Amendments to: State Air Quality Control Plan

Volume III: Appendix III.K.6 Best Available Retrofit Technology (BART) Documentation

DEC GVEA BART Final Determination Report 2-5-10 (revised 6-1-10)

DEC GVEA BART Final RTC 2-5-10

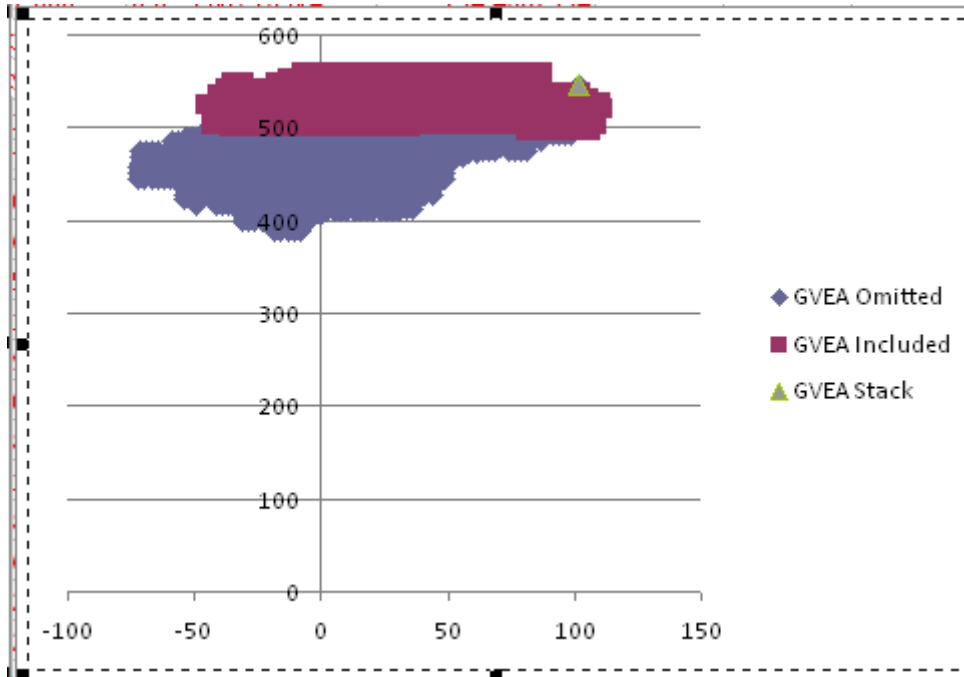
The maximum modeled visibility impact associated with Auxiliary #1 Boiler using corrected maximum NO_x and SO₂ emission rates continues to show this emission unit is not predicted to cause or contribute to visibility impairment at DNP.

It is noted that the Auxiliary #1 Boiler revised maximum visibility impact presented above occurred at a location included in GVEA's visibility modeling analysis. Therefore, the revised

maximum impact is attributable solely to the corrected unit NO_x and SO₂ emission rates. The 776 previously omitted receptors are relatively distant from the Healy Power Station, and the 591 receptors initially modeled by GVEA are located in relatively close proximity to the plant and remain the dominant receptors in this analysis. The figure below shows the locations of these groups of receptors relative to the Healy Power Station.

While this analysis has focused on GVEA's Auxiliary #1 Boiler, GVEA's omission of the 776 receptors may affect their prior visibility modeling for Healy Unit 1. GVEA omitted the same 776 receptors from the Healy Unit 1 Calpost input files. As such, Enviroplan conducted revised Calpuff/Calpost modeling of Healy Unit 1. The analysis was limited to the GVEA Healy 1 baseline configuration (i.e., maximum daily NO_x, SO₂ and PM emission rates) scenario. Enviroplan corrected GVEA's Calpost **NDRECP** option to include all 1367 receptors; and no other changes were made to GVEA modeling files.
